COUNCIL ASSESSMENT REPORT

Panel Reference	PPSHCC-61
DA Number	DA 59571/2020
LGA	Central Coast Council
Proposed Development	Demolition of existing structures and construction of four residential flat buildings, containing 131 units including 10 affordable housing units, basement parking and landscaping works at 89-91 Karalta Road, Erina
Street Address	89-91 Karalta Road, Erina Lot 1 and Lot 2, DP 259824
Applicant/Owner	Applicant – Cain King CKDS Architecture Pty Ltd Owner - D J & D E McNeish
Date of DA lodgement	5 November 2020
Total number of Submissions Number of Unique Objections	Two
Recommendation	Refusal
Regional Development Criteria (Schedule 7 of the SEPP (State and Regional Development) 2011	Capital Investment Value > \$30M CIV of \$43,023,453
List of all relevant s4.15(1)(a) matters	<ul style="list-style-type: none"> • <i>Environmental Planning & Assessment Act 1979 (EP&A Act)</i> • <i>Local Government Act 1993 (LG Act)</i> • <i>Roads Act 1993 (Roads Act)</i> • <i>Environment Protection and Biodiversity Conservation Act 1999 (EPBC Act).</i> • <i>Biodiversity Conservation Act 2016 (BC Act).</i> • <i>State Environmental Planning Policy (State and Regional Development) 2011 (

Figure 13 – Extract of architectural drawing DA-4003 SEPP65 cross ventilation diagram, red crosses showing example of where single aspect units are counted as naturally cross ventilated, relying on small slots on the same side of the building

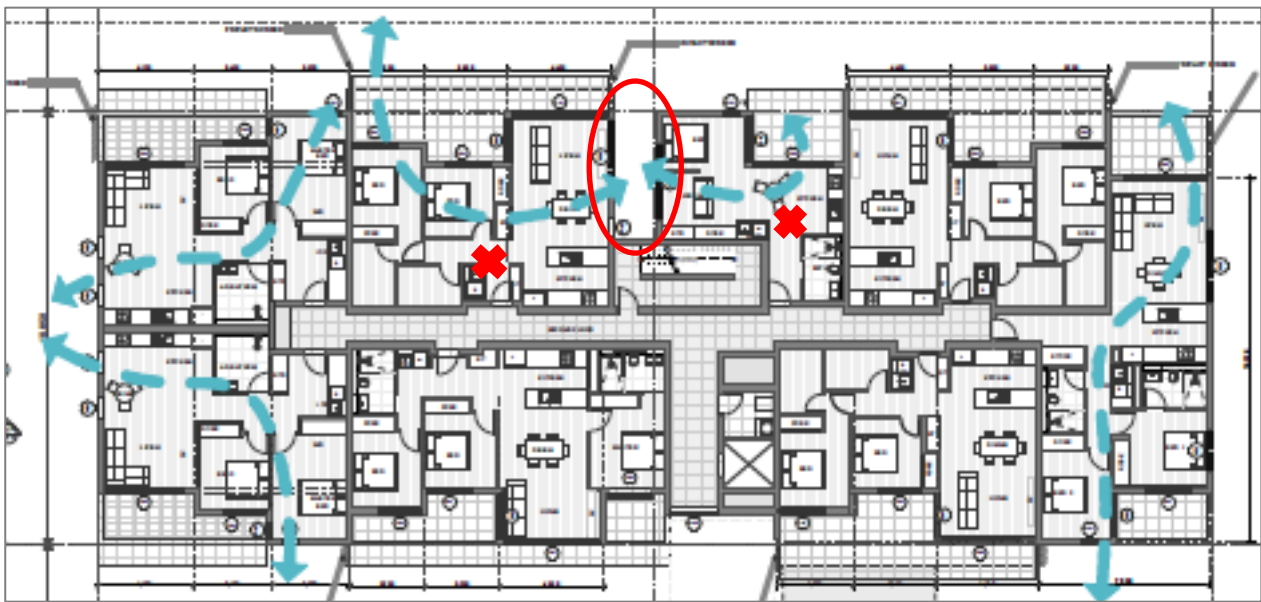
- Natural ventilation - Although the numerical figure has been achieved, the effectiveness of the units’ ventilation into the building slot at the stair wells is questioned. This is a dead corner or pocket with airflow being minimal. The redesign of the common stair areas into a “through flowing” zone with louvres would create natural air flow for this to operate effectively.

Design Criteria	Required	Proposed	Compliance
		<p>However, a number of single aspect apartments are counted as naturally cross ventilated based on indents/slots within the building façade (see Figure 13 below).</p> <p>This appears to apply to 18 units, which would reduce natural cross ventilation to 65/131 or 49.6%. This is well below the 60% requirement under the ADG.</p> <p>An engineering report, prepared by GHD, has been provided by the applicant that outlines that the difference in wind pressure coefficients between inlet and outlet will drive the airflow through the apartments.</p> <p>The effectiveness of the units' ventilation into the building indents/slots is questioned. These are a dead corner or pockets with airflow being minimal.</p>	being compliant, will be capable of being cross-ventilated.
4C-1 Ceiling Heights	Minimum 2.7m	3.1m floor to floor heights provided which will allow for 2.7m floor to ceiling.	Yes

Figure 15 - Height Plane Diagram – Drawing DA-4005

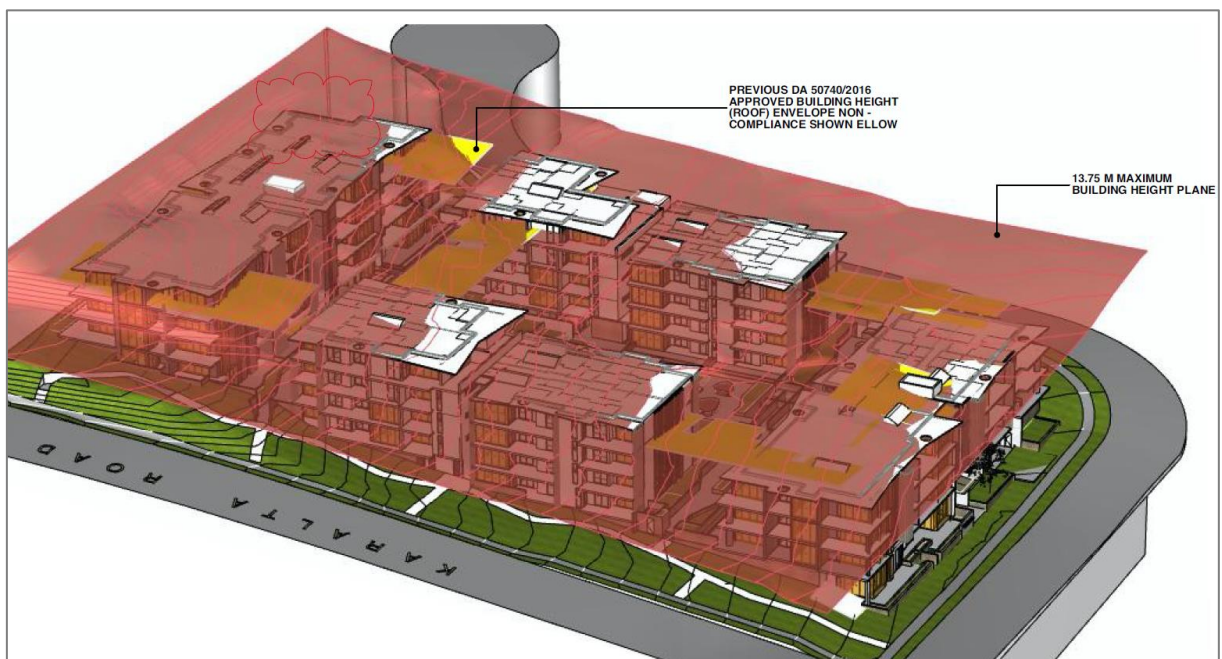
The buildings are excessive in bulk and scale. They are long and homogenous with little articulation and there are concerns regarding the internal amenity of the units, as discussed above in the SEPP 65 section. In addition, the siting of the buildings has not complemented the natural topography of the site. Accordingly, it is considered the development does not achieve high quality urban form.

Figure 17 - Extract from concept CMP Stage 2

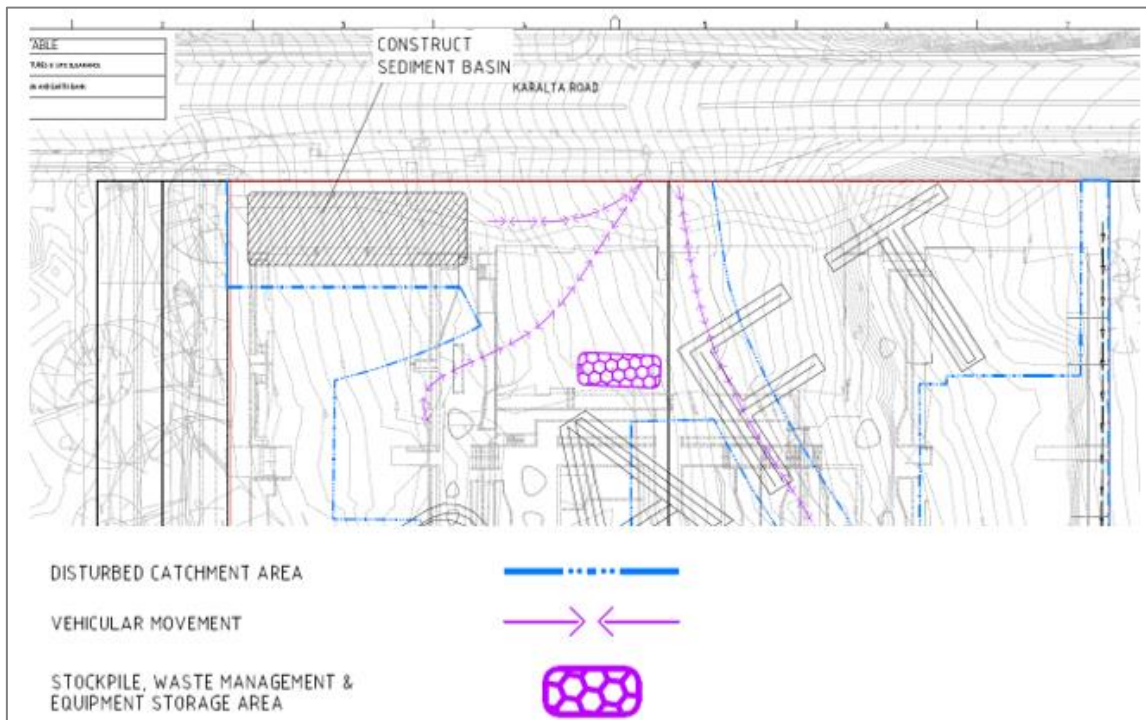
The civil plans identify a large sediment basin, construction vehicle access and movements, level changes, stormwater infrastructure and stockpiling of spoil and other materials in this area as shown in the extract from the concept construction management plan stage 2 below.

Figure 18 - Extract from Appendix 4 of Arborist Report

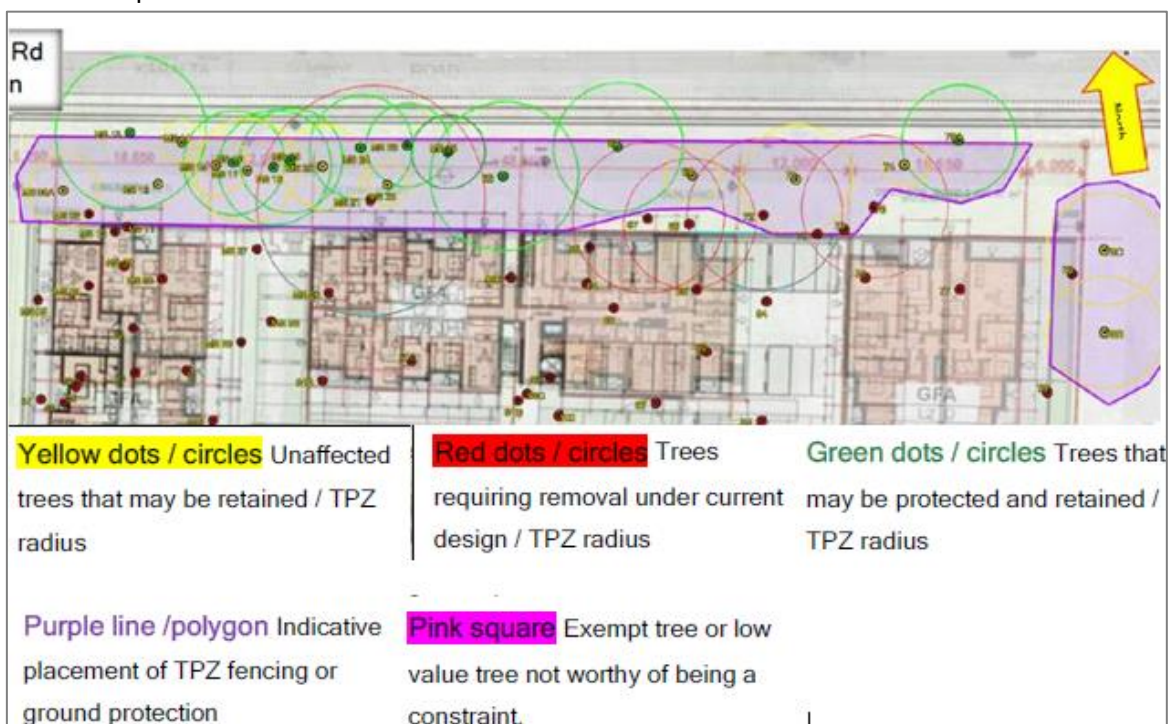
Moreover, the Arborist report (at section 8.14) states *"Many of the trees located along the northern periphery of the site between Karalta Road and the proposed northern edge of proposed works may be retained depending on the specifics of the final design in this area."*(refer to extract from Appendix 4 of Arborist report below). It further discusses that retention of vegetation in this area will relate to the extent of soil disturbance within these Tree Protection Zones (TPZ's) and whether there is to be footpath with kerb and gutter or a nature strip.

Figure 20 – Western boundary detail – Building A interface with 11 Jennie Cox Close

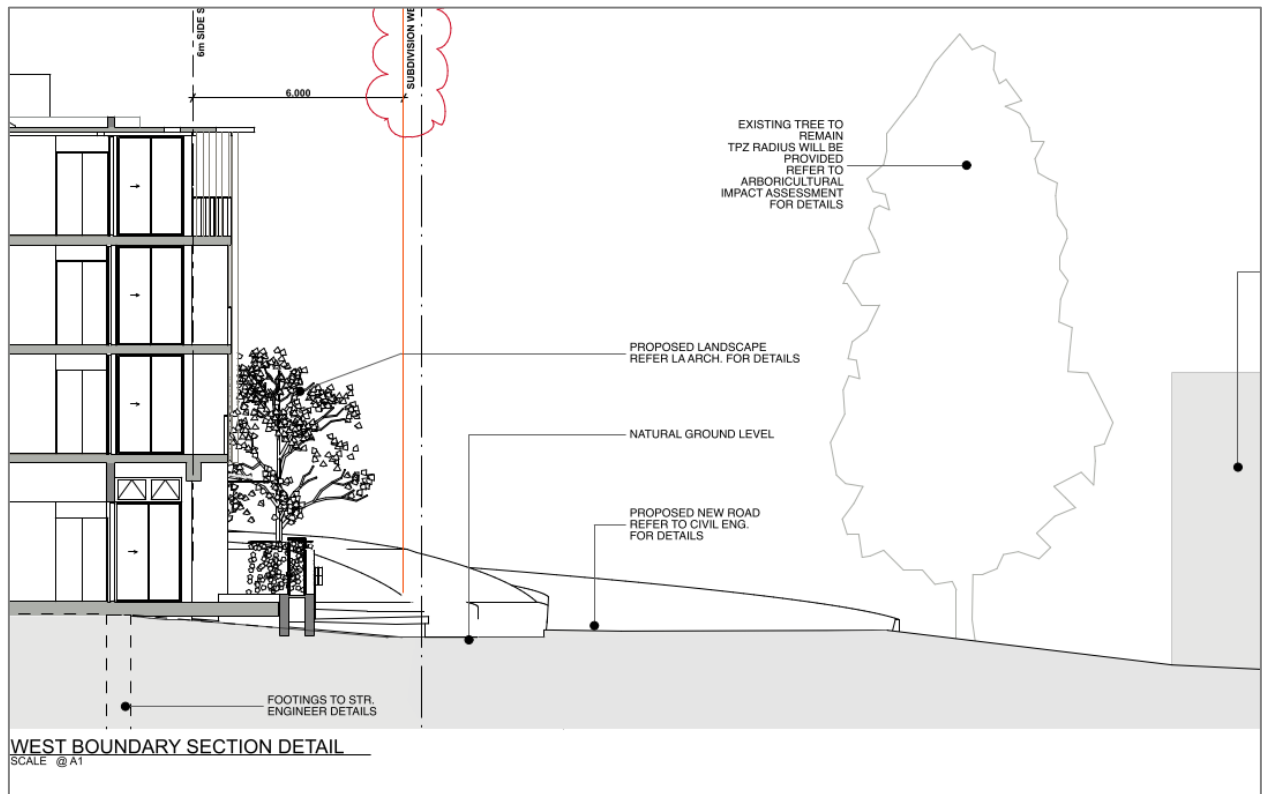
Consideration should have been given to a greater setback and to allow for the provision of deep soil planting for larger trees. The detailed section, see Figure 21, notes an 'existing tree to remain', however if 93 Karalta Road were to be developed in the same way as the subject site, this tree would be lost and there would be a 10m separation between balconies, instead of the 12m required by the Apartment Design Guide. This interface is negatively exacerbated by building D's excessive, unbroken length of 58m, which would provide no visual relief to any future development to the east.

Figure 22 – Demolition Plan extract - DA-0006 issue H

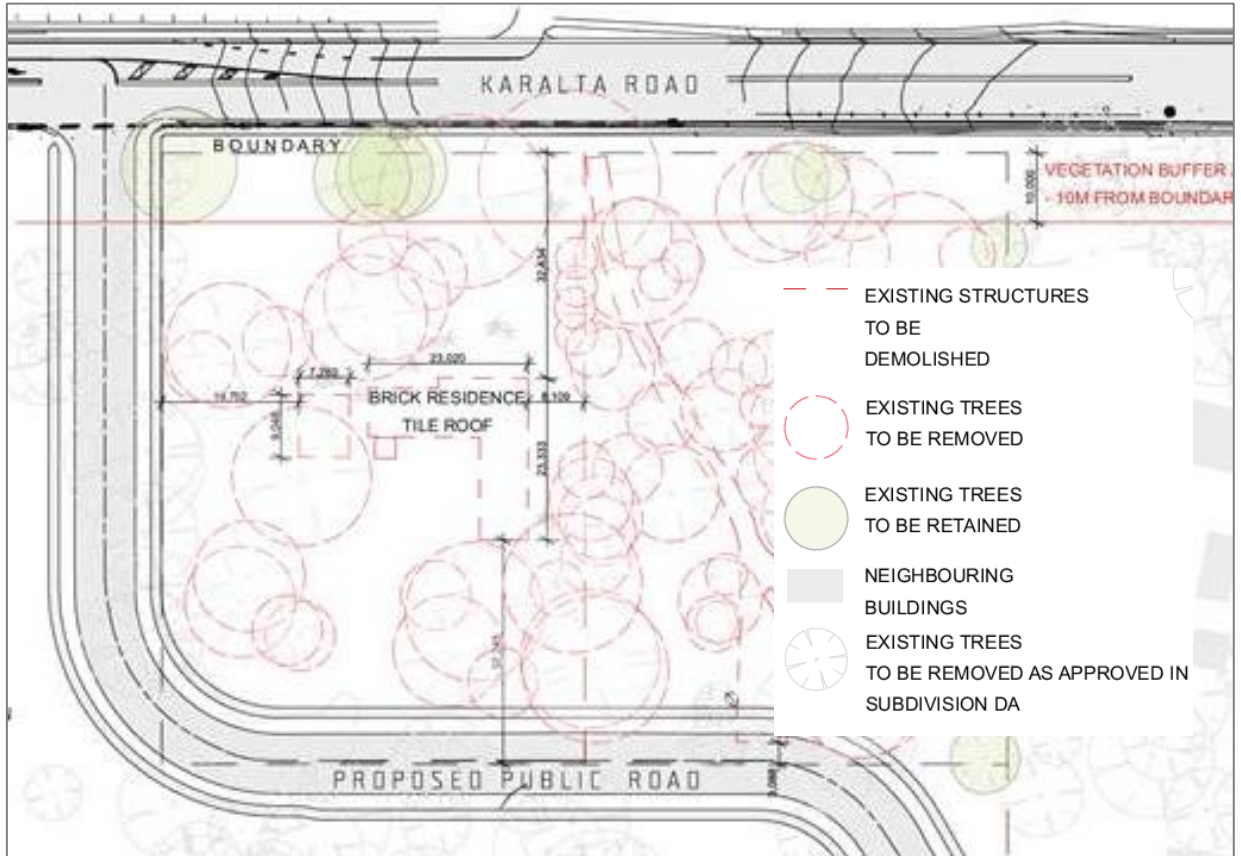
As per previous discussion in the report, conflicting documentation has been provided in relation to tree removal, particularly within the 10m northern setback area. The demolition plan identifies the retention of 5-6 trees in the northern setback area (refer Figure 22) whilst the landscape plans identify 21 trees to be retained and protected (refer figures 23 and 24).

Figure 25 – Arborist Report Appendix 4 images /maps

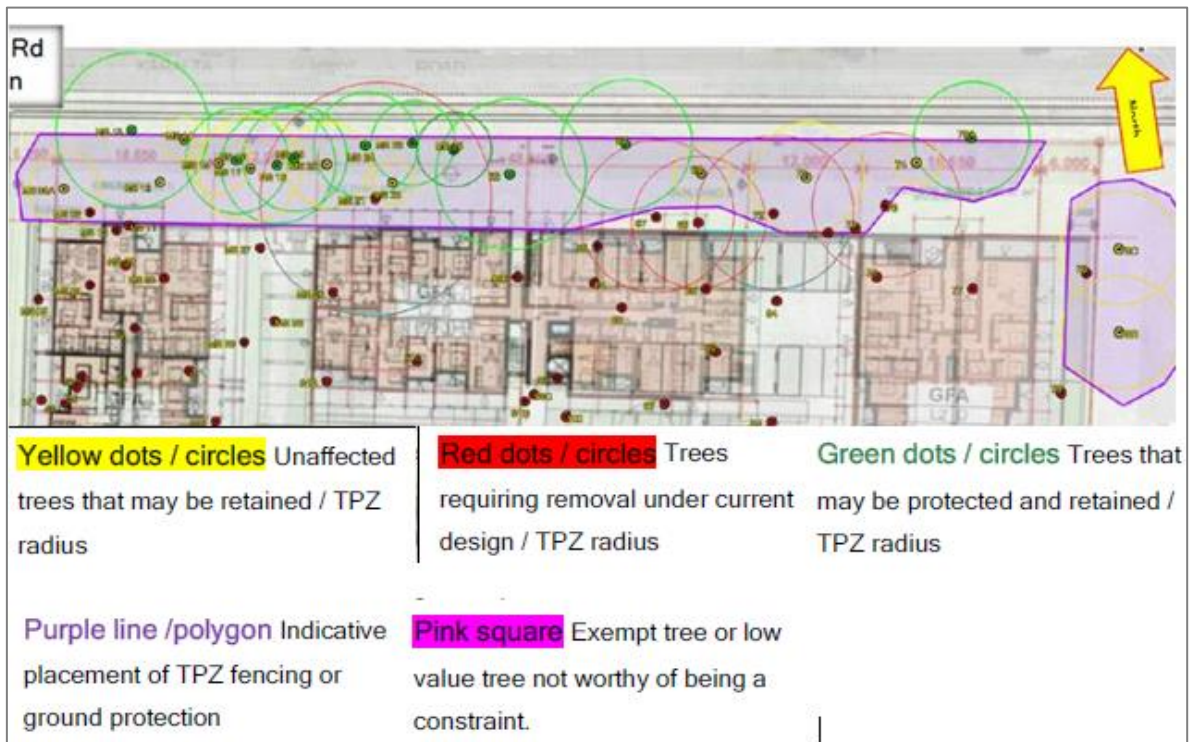
8.19. If kerb and guttering and associated soil levelling and disturbance is proposed, many of these trees and in particular, the trees indicated with a lime green dot and TPZ circle, will require removal to facilitate the installation of infrastructure.

8.20. It is not possible to determine the likely fate of trees in this section until specifics of the design for this area have been developed and finalised.

Figure 26 - Concept Construction Management Plan Stage 2 - PS01-B101 Rev A

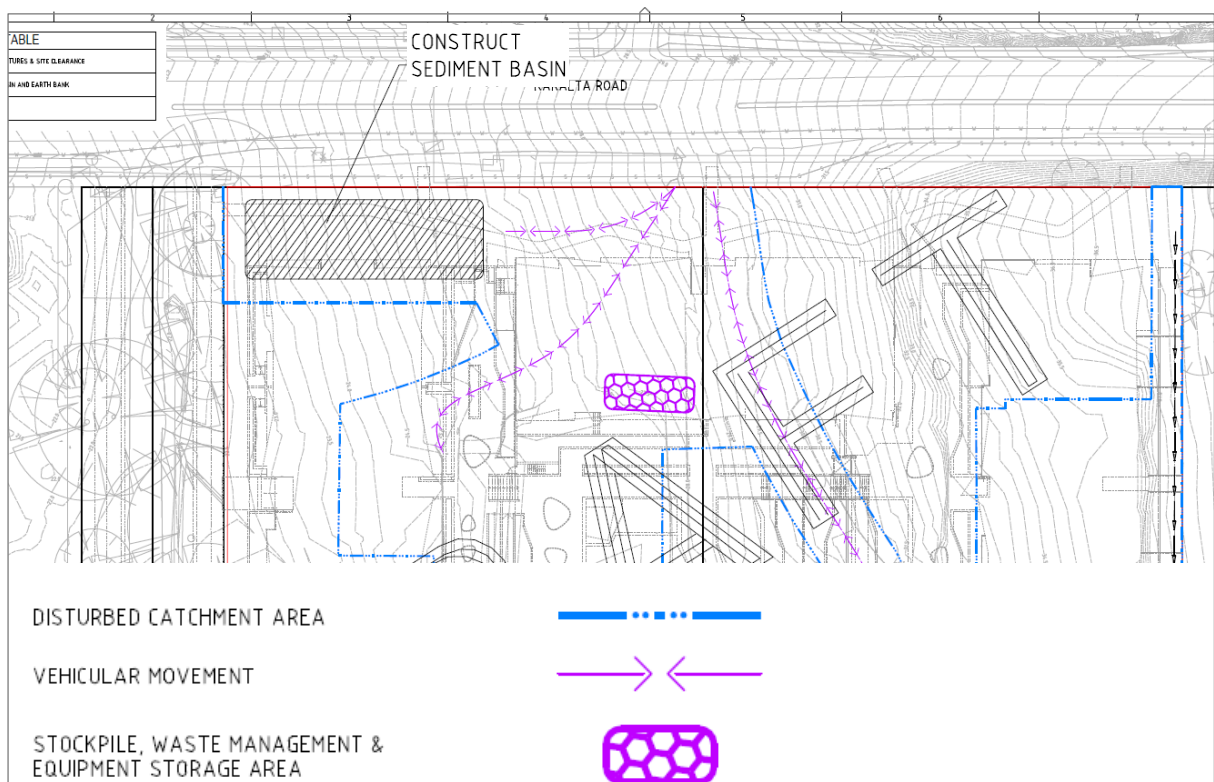
The Civil plans show construction vehicle access and movements, the construction of a large sediment basin, construction stockpile areas, cut and fill / level changes and stormwater infrastructure within the 10m northern setback area as shown in figures 26-29 below.

Given the inconsistent information between the architectural and landscape plans and uncertainty of the advice contained within the Arborist report, it is not clear what trees are proposed to be removed or can be retained. Concern is raised that there will be no existing vegetation retained within the 10m landscape buffer proposed adjacent to Karalta Road. Removal of all of this vegetation is likely to have an unacceptable impact on the amenity of the site and streetscape, particularly given the type of development proposed.
